# Access Compliance Report

## Public Rights-of-Way

### (Curb Ramps)

Intersection ID: 28212	Main Street: CHASEWATER_DR	Cross Street: DARBY_CHASE_DR	Location: E
ADA ID: C79ACA1DD723	Ramp Type: PerpDiag	Initial Pass/Fail: Fail	Overall Compliance: No
Severity Score: 12.5			
Codes/Mitigation Info/Possible Solution		Field Measurements/Component Compliance

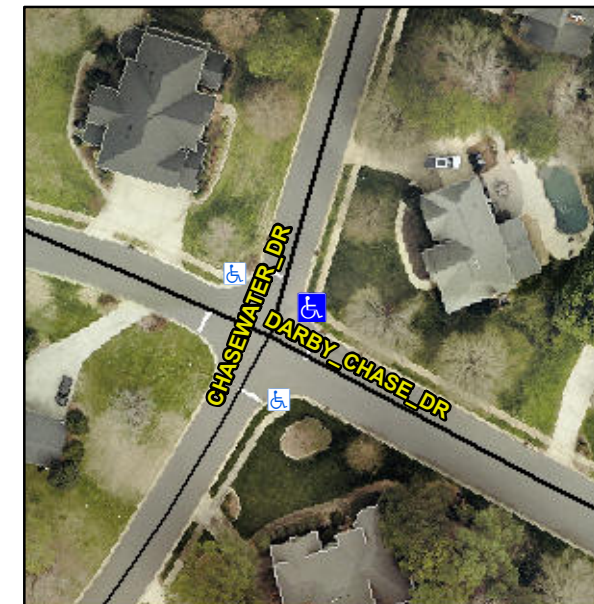
**Not Found, R304.2.2**

Compliance	Description	Data	Compliance	Description	Data
N/A	Ramp Length (in)	48.0	No	Ramp Slope (%)	8.4
Yes	Ramp Width (in)	48.0	Yes	Ramp XSlope (%)	2.0
N/A	Flare Type LT	N/A	N/A	Flare Type RT	N/A
N/A	Flare Slope LT (%)	N/A	N/A	Flare Slope RT (%)	N/A
N/A	Flare Traversable LT?	N/A	N/A	Flare Traversable RT?	N/A
N/A	Landing Length (in)	N/A	N/A	DWS Provided?	N/A
N/A	Landing Width (in)	N/A	N/A	DWS Contrast?	N/A
N/A	Landing Slope (%)	N/A	N/A	DWS Length (in)	N/A
N/A	Landing X Slope (%)	N/A	N/A	DWS Full Width?	N/A
N/A	Landing Curb? (Y/N)	N/A	N/A	DWS Offset (in)	N/A
N/A	Shared Landing?	N/A			
N/A	Gutter Ponding?	N/A	N/A	Gutter Slope (%)	N/A
N/A	Gutter Lip Ht (in)	N/A	N/A	Gutter X Slope (%)	N/A
N/A	Painted X Walk1?	No	N/A	Painted X Walk2?	No
	X Walk 1 Direction	To NW		X Walk 2 Direction	To SW
N/A	X Walk 1 Width (in)	N/A	N/A	X Walk 2 Width (in)	N/A
	X Walk 1 Slope (%)	1.6		X Walk 2 Slope (%)	1.1
	X Walk 1 X Slope (%)	0.9		X Walk 2 X Slope (%)	1.5

**Remove & Replace Curb Ramp With Two New Directional Ramps or Equivalent.**
